# UNITED STATES PATENT AND TRADEMARK OFFICE

APPLICATION NO.	FILING DATE	FIRST NAMED INVENTOR	ATTORNEY DOCKET NO.	CONFIRMATION NO.
10/776,218	02/12/2004	Raul Montanana	3011-1002	3173

## **DETAILED ACTION**

This is a first office action on the merits of patent application S. N. 10/776,218.

Claims 1-3 and 5-7 are rejected under 35 U.S.C. 102(b) as being anticipated by FR ('579).

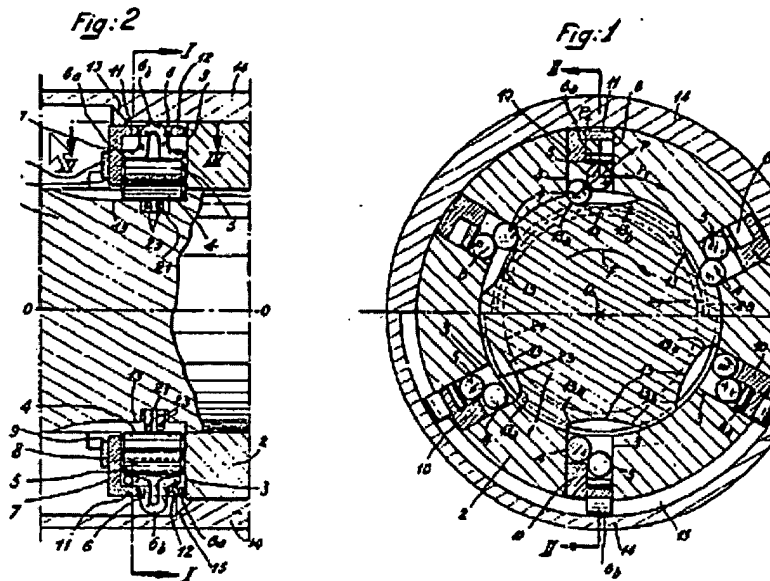
FR ('579) discloses a positive engagement clutch comprising an input side, an output side, a torque input member, a torque output member, first engagement members (4), second engagement members (5), a common axis, projecting and retracting positions, a gap, and bearings.

Claims 1 and 3-7 are rejected under 35 U.S.C. 102(b) as being anticipated by FR ('290).

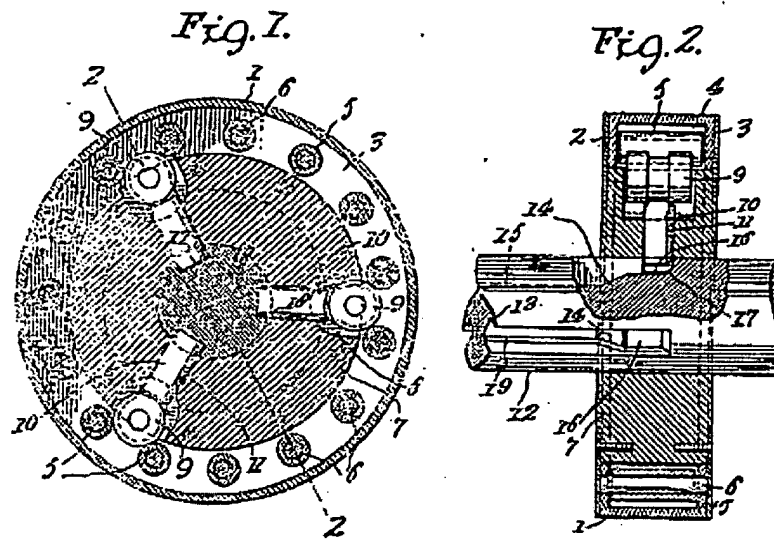
FR ('290) discloses a positive engagement clutch comprising an input side, an output side, a torque input member, a torque output member, first engagement members, second engagement members, a common axis, projecting and retracting positions, a gap, rollers (9), a push rod element (16).
